WASHINGTON UTILITIES AND TRANSPORTATION COMMISSION

PETITION TO MODIFY HIGHWAY-
RAIL GRADE CROSSING ACTIVE
WARNING DEVICES

USDOT CROSSING # 066074B

UTC CROSSING # 51A74.40

Section 7 – Illustration of Proposed Warning Devices

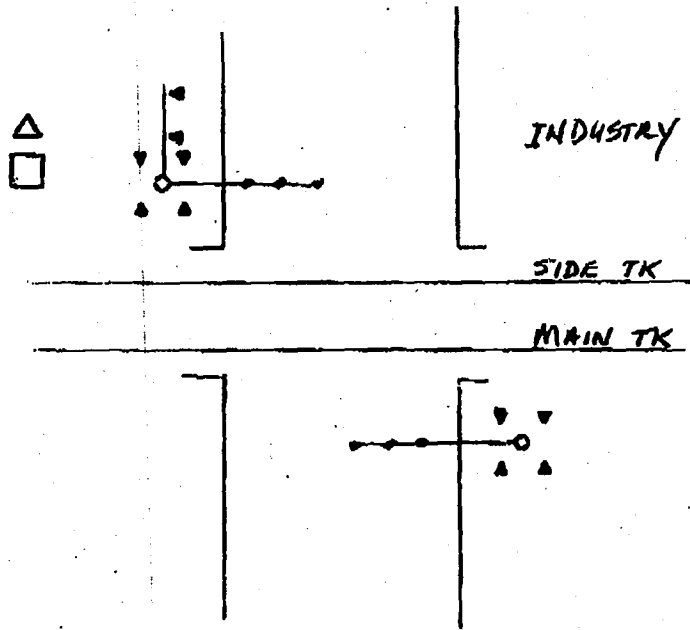
SHOULDER MOUNTED 8" FLASHING LIGHTS,
BELL, X-BUCKS, DC TRAIN DETECTION.

WITH GATES
SHOULDER MOUNTED 12" FLASHING LIGHTS BELL,
X-BUCKS, AC/DC TRAIN DETECTION.
